COUNCIL ASSESSMENT REPORT

Panel Reference	PPSSNH-644
DA Number	eDA0255/25
LGA	Ku-ring-gai
Proposed Development	Demolition of existing buildings, construction of a 120 place child-care centre and associated works.
Street Address	4B and 8 Charlton Avenue, Turramurra
Applicant/Owner	Aremade Architectural Pty Ltd for Sydney North Shore Investment Pty Ltd
Date of DA lodgement	29 May 2025
Total number of Submissions	52
Number of Unique Objections	>10
Recommendation	Refusal
Regional Development Criteria (Schedule 1 of the SEPP (Planning Systems) 2021)	Estimated development cost of greater than \$5 million
List of all relevant s4.15(1)(a) matters	<ul style="list-style-type: none"> Environmental Planning and Assessment Act 1979 Environmental Planning & Assessment Regulation 2021 SEPP (Biodiversity & Conservation) 2021 - Chapters 2 and 9 SEPP (Transport and Infrastructure) 2021 – Chapter 3 Educational establishments and child-care facilities SEPP (Resilience and Hazards) 2021 SEPP (Sustainable Buildings) 2022 Ku-ring-gai Local Environmental Plan 2015 (KLEP 2015) Ku-ring-gai Development Control Plan (KDCP) Ku-ring-gai Contributions Plan 2023 Education and Care Services National Regulations (

Figure 7: plan showing the proposed building footprint

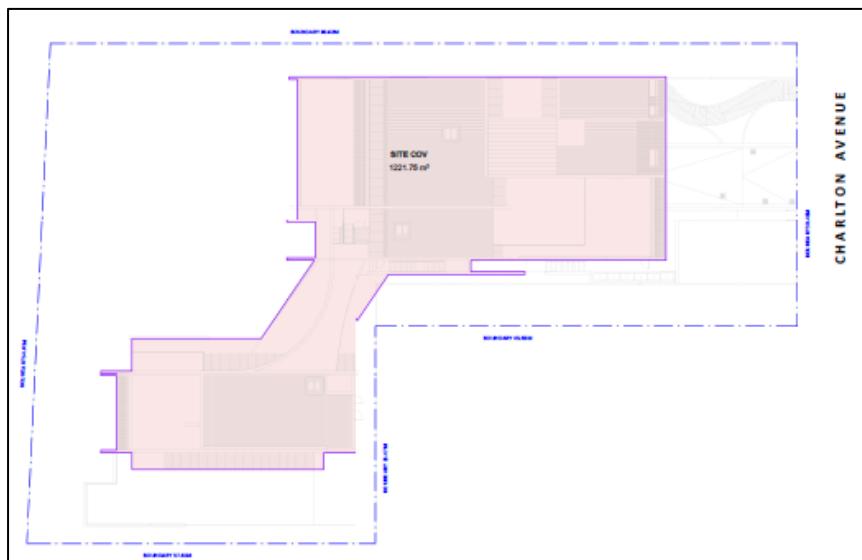
The childcare centre is designed for a large but constrained site of 3,348.3 m², which includes biodiversity areas to the rear (**Figure 4**). **Figure 11** shows an angled view comparing the proposed centre with the neighbouring houses. The visual comparison highlights the new buildings being significantly larger with a different building form than the surrounding dwellings.

Figure 9: plan showing cross-section of the front building facing Charlton Avenue, Turramurra

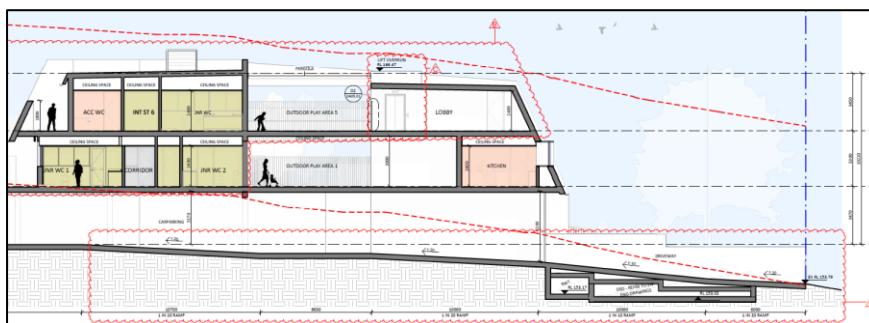
The site is located on the high side of the street. **Figure 11** shows the site with two separate buildings over the basement. Acoustic walls, measuring 1.39 metres, 1.8 metres, and 2.1 metres, are provided to the outdoor play areas at both ground and first floor levels for the respective buildings. **Figures 8 and 9** show a 3 storeys building façade facing Charlton Avenue.

The slope of land is less than 15%, as calculated by spot levels shown on the survey plan. As shown within **Figure 9**, the driveway slope is less than the natural ground level (shown as red dashed lines). Excavation is proposed for the driveway, which shows a reduced slope, which is acceptable. Council's Team Leader, Development Engineers is satisfied that the driveway complies with the relevant Australian Standards.

Figure 10: plan showing trees retained and removed

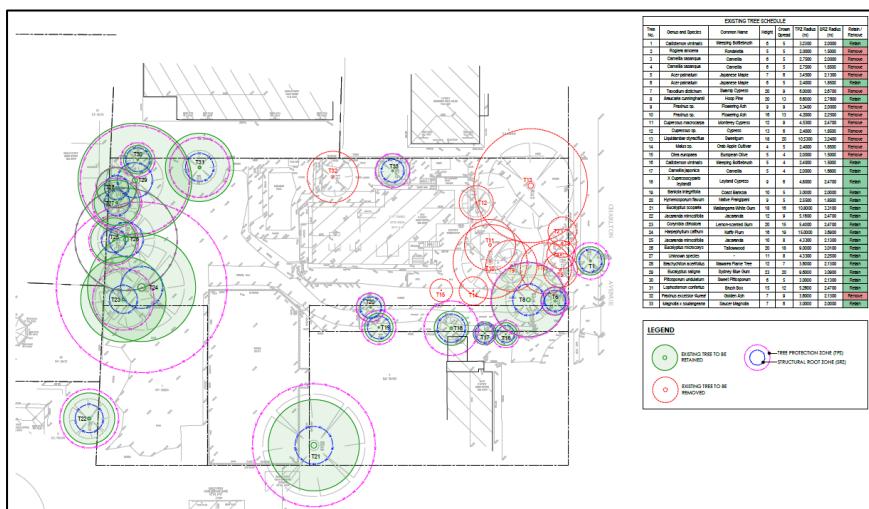
Council's Landscape and Tree Assessment Officer supports the proposed tree removal subject to replacement trees being provided, which is agreed. However, concerns are raised that the design of the front setback does not provide conditions for suitable tree planting, as a result the application is not supported in this regard.

Figure 11: plan showing oblique view of site and adjoining buildings

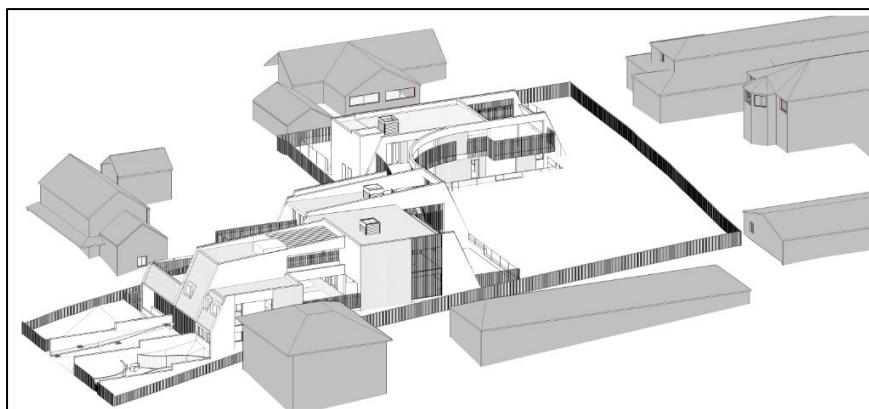
The northern side building setback measuring 3.65 metres does not meet the 4.2 metres requirement in Control 11 of Part 4A.2 of KDCP. As shown within Figure 11, the northern façade provides a two storey development above a basement. A side setback of 3.6 metres is compatible with the streetscape character and marginally exceeds the minimum northern side setback of the existing dwelling on the site, which is approximately 3.2 metres. Screen planting in scale with the building is provided in the side setback, accordingly the variation to the side setback control is acceptable as the relevant objectives are achieved.

Figure 12: plan showing deletion of retaining wall and relocated pathway

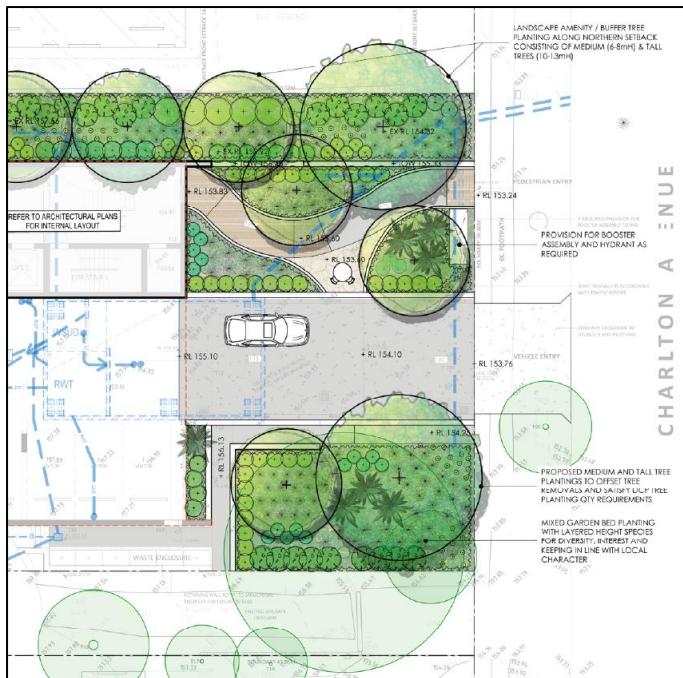
Whilst the amended plans have deleted the front car park, the amended plans propose driveway and pathway retaining walls that extend to the front property boundary and impact deep soil areas, which is incompatible with the character of adjoining dwellings and detracts from the established landscape setting. Council's Senior Landscape and Tree Assessment Officer has assessed the amended Landscape plans (**Attachment 6**) and does not support the extent of excavation and landscape design, which is agreed. This forms a recommended reason for refusal.
